RECEIPT DATE: 10/24/19 **ONSITE SEWAGE DISPOSAL SYSTEM** P 56648

RE: 12225 Hayland Farm Way, Walnut Creek Lot 161, OSDS Design Plan comments

LOT 161
SEPTIC SYSTEM
INSTALLATION SITE PLAN
WALNUT CREEK
PHASE THREE

LOT 161
SEPTIC SYSTEM
INSTALLATION SITE PLAN
WALNUT CREEK
PHASE THREE

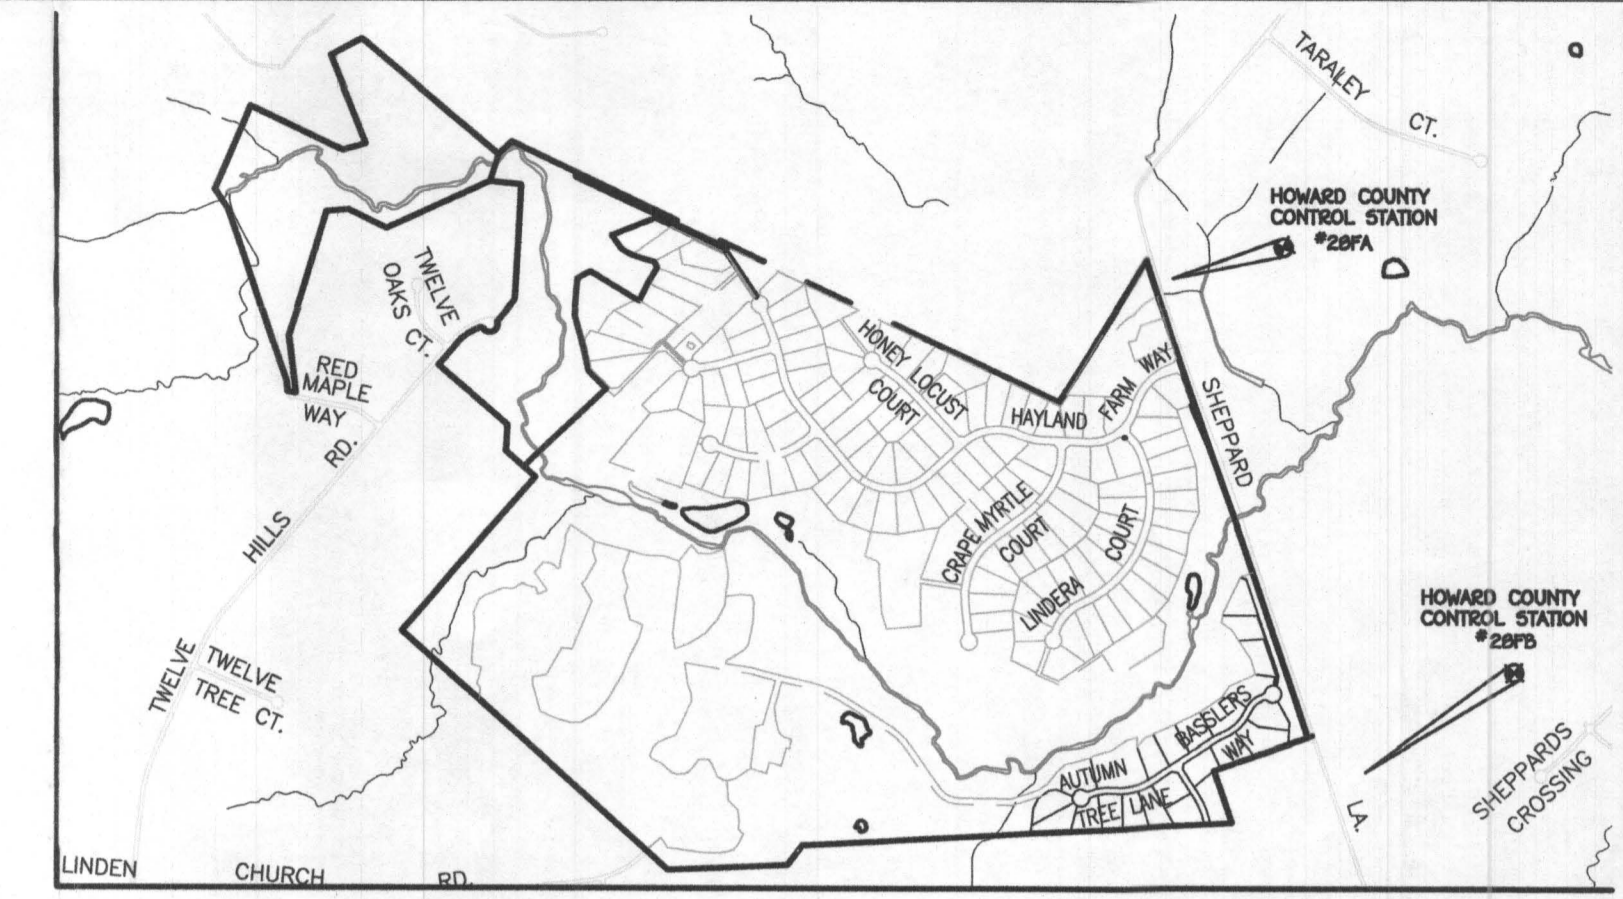
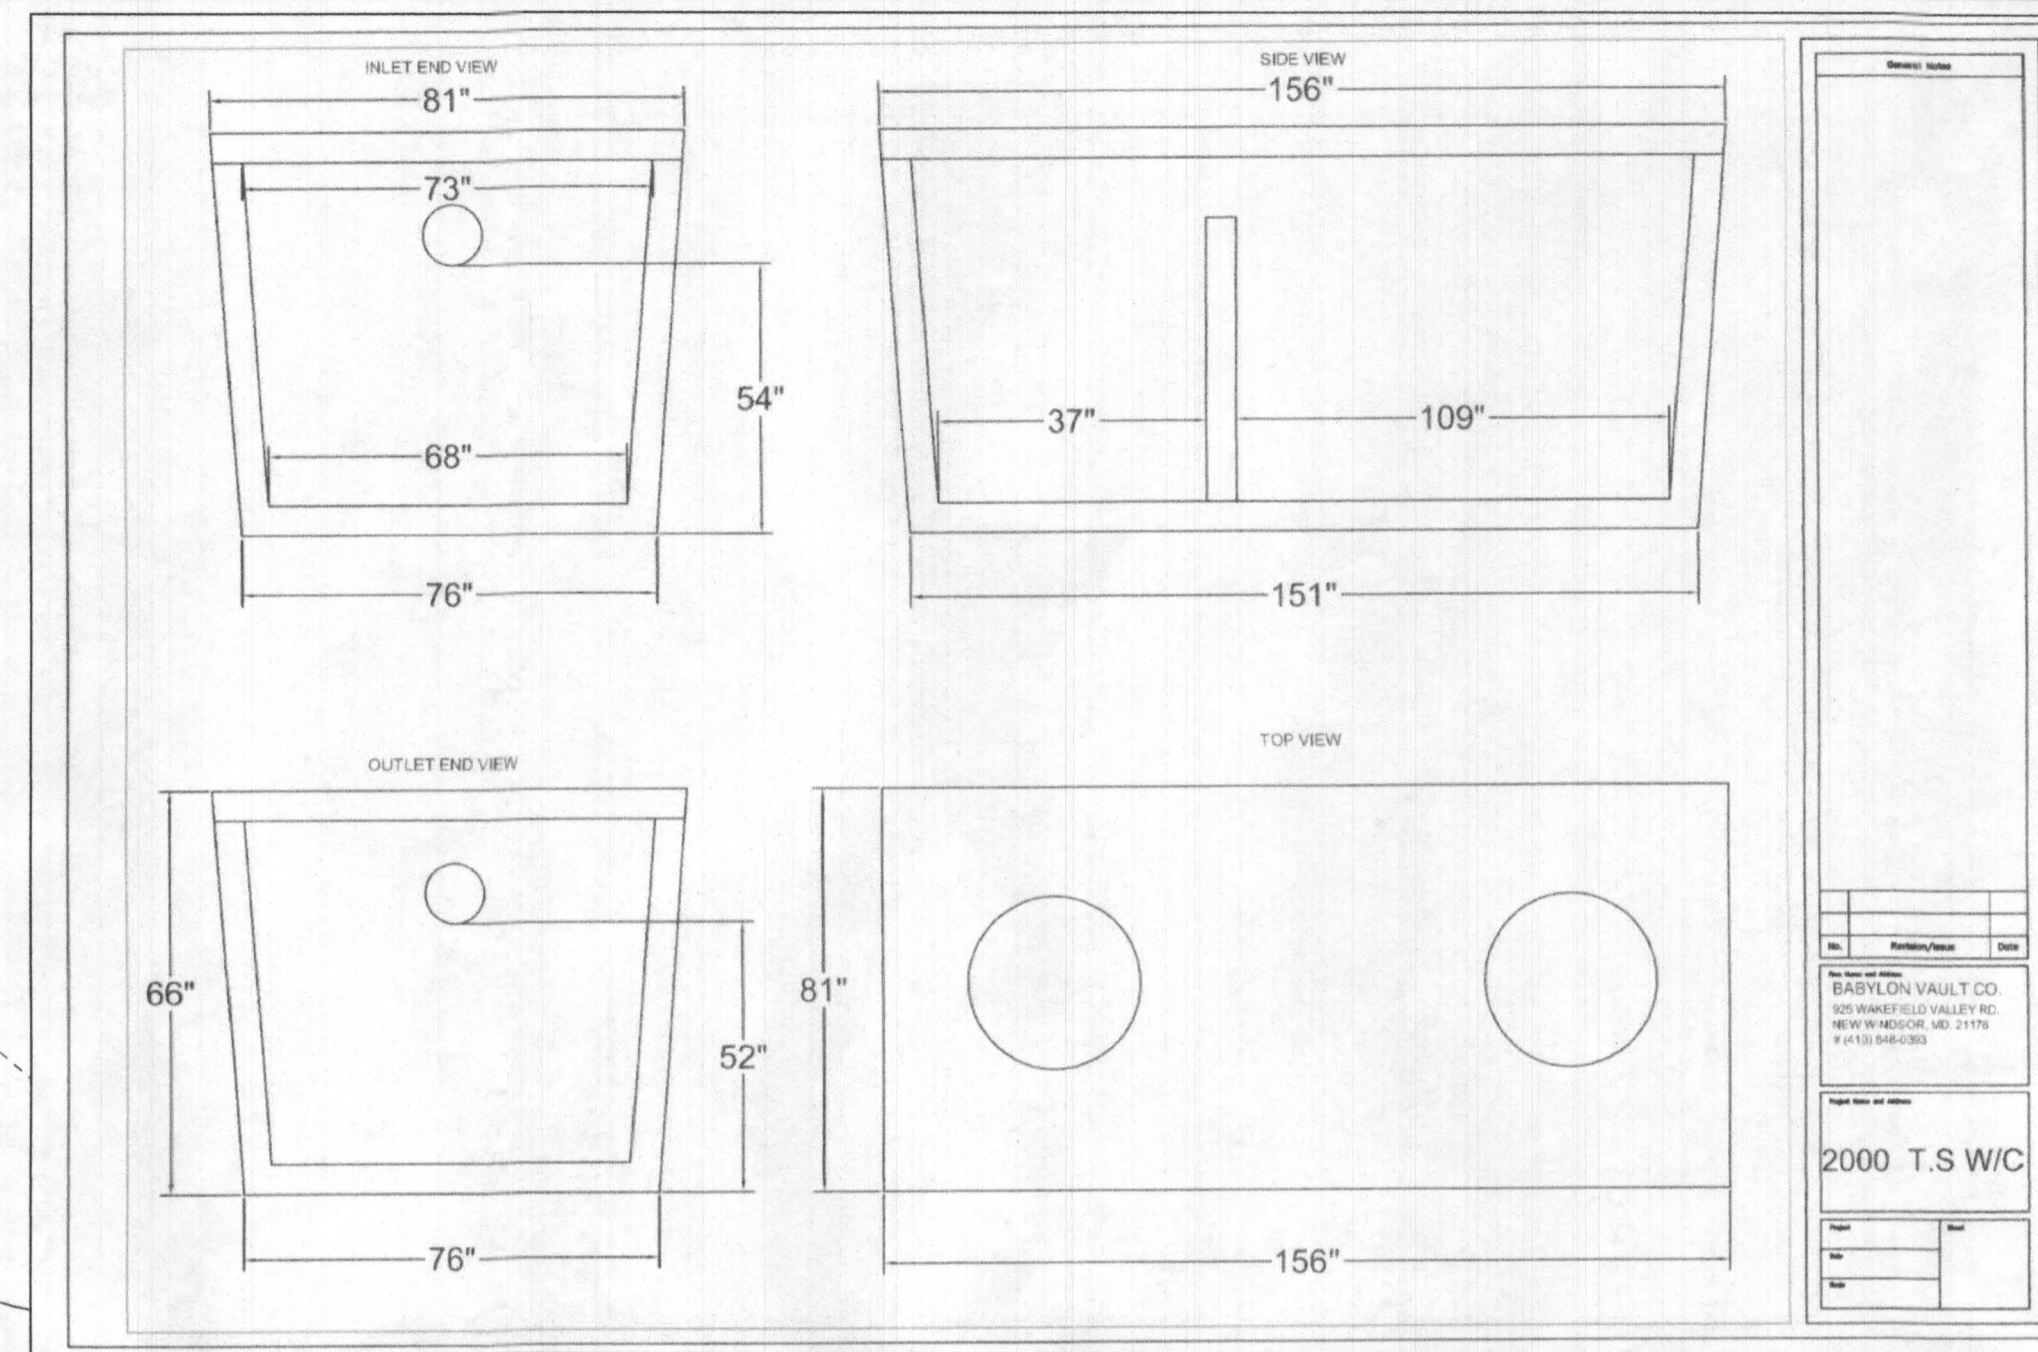
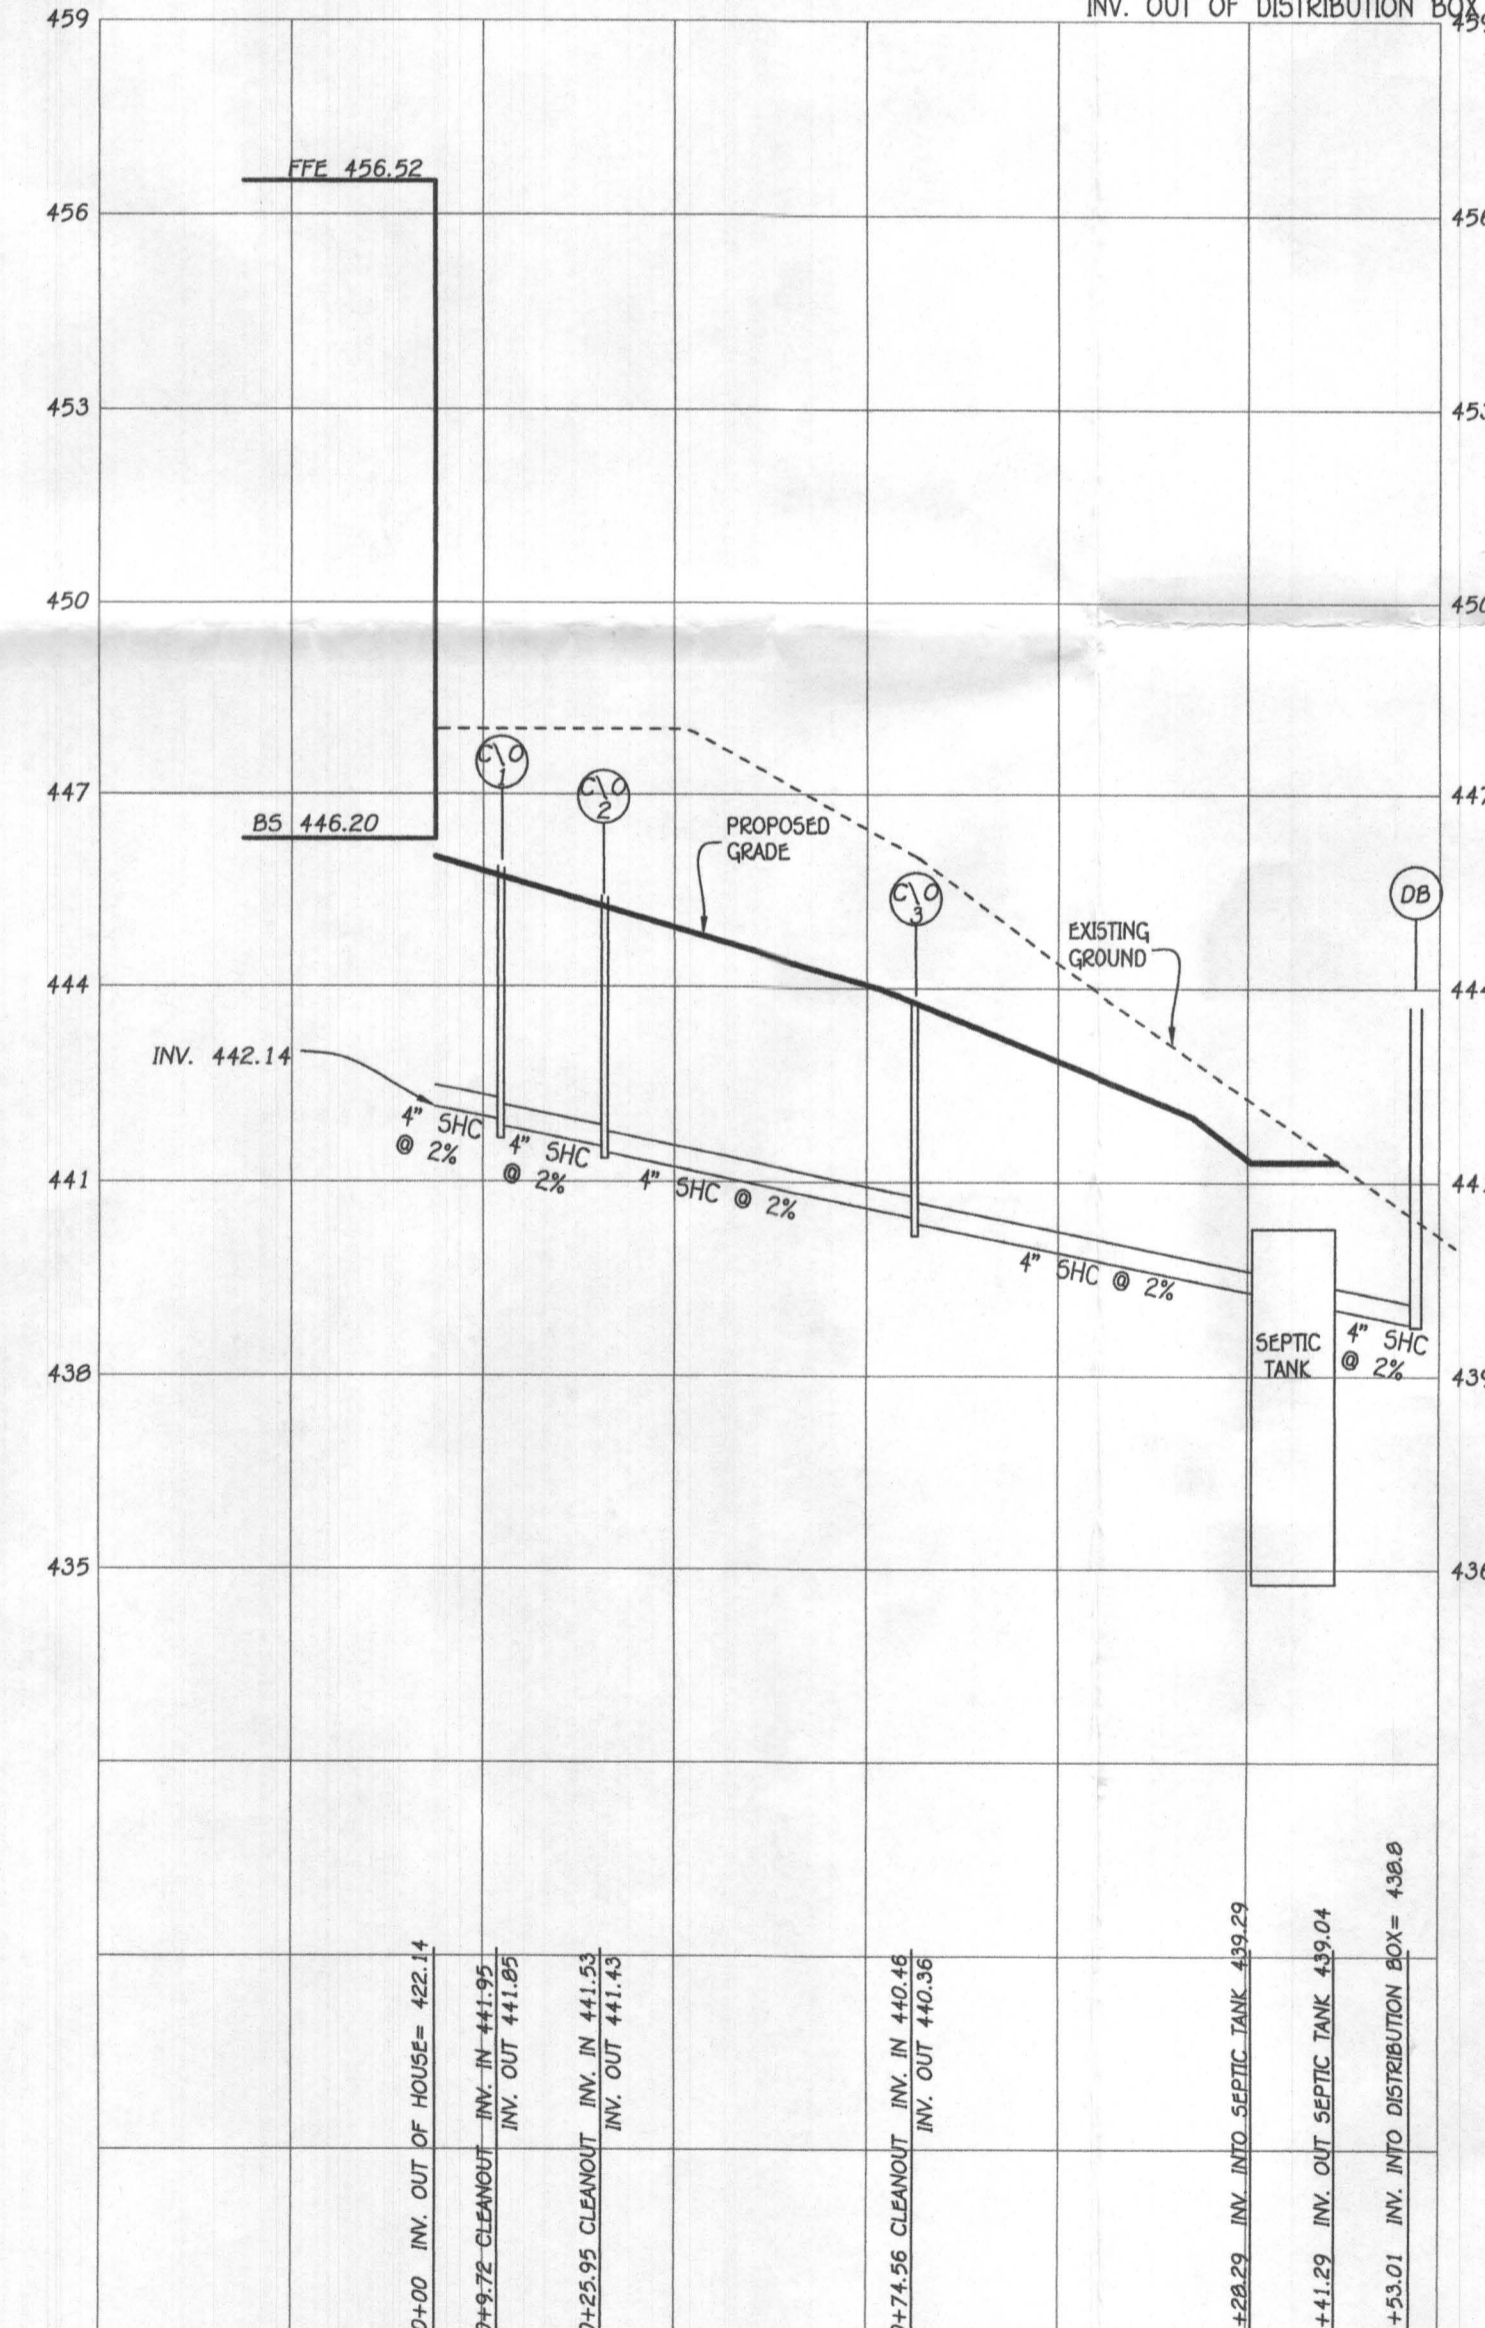
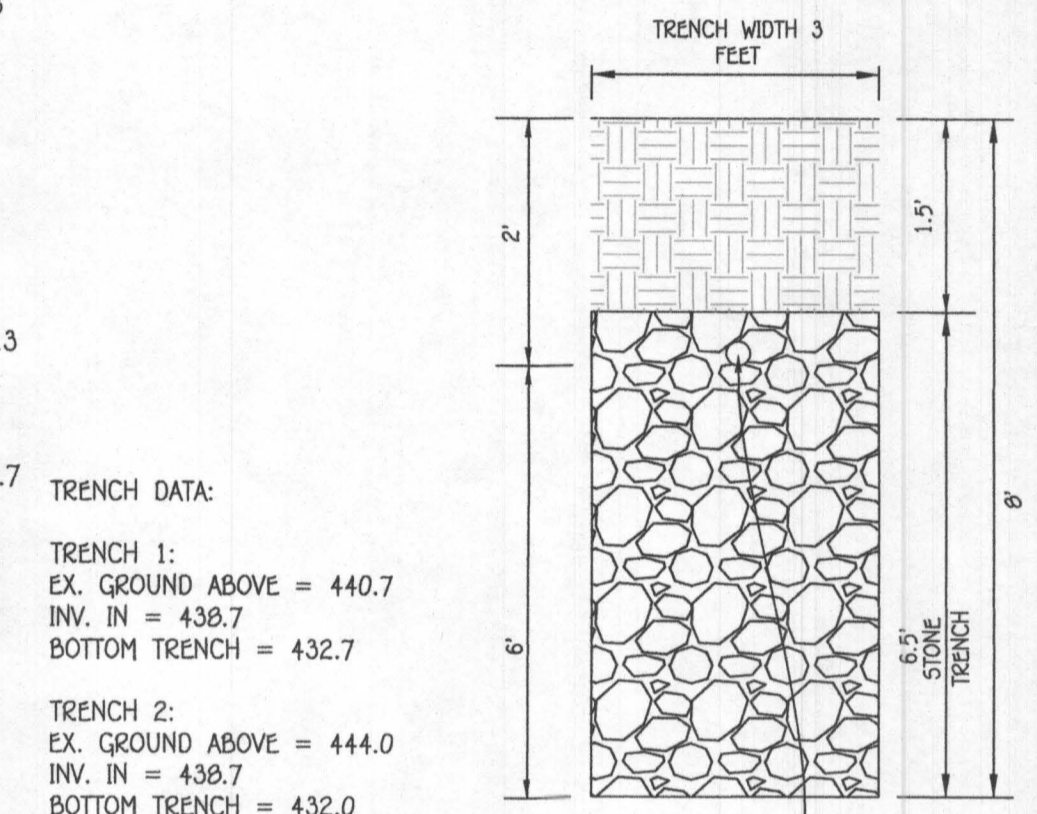
The following issues were noted for revision during review of the submitted OSDS Design Plan. Building Permit Application B19001221 is 'On Hold' and shall remain 'On Hold' until these issues are resolved. When resolved, a revision of the Plot Plan must be submitted along with a formal revisions sheet at the Department of Inspections, Licenses, and Permits.

1. The septic tank is proposed against the upper boundary of the sewage disposal area.
 - a. Shift the septic tank location about 5 feet or so uphill.
 - b. Shift the Initial System trenches uphill several feet so that a portion of the upper trench is against the SDA boundary
2. The driveway encroaches on the 10-ft setback from the well zone, and the driveway is only about 8 to 9 feet from the existing well.
 - a. Typically, a revision of the Percolation Certification Plan is required to re-configure the well zone
 - b. The driveway should be moved enough to create a 10-ft setback to the existing well.
 - c. You may request to redline edit the current Percolation Certification Plan for Lot 161.
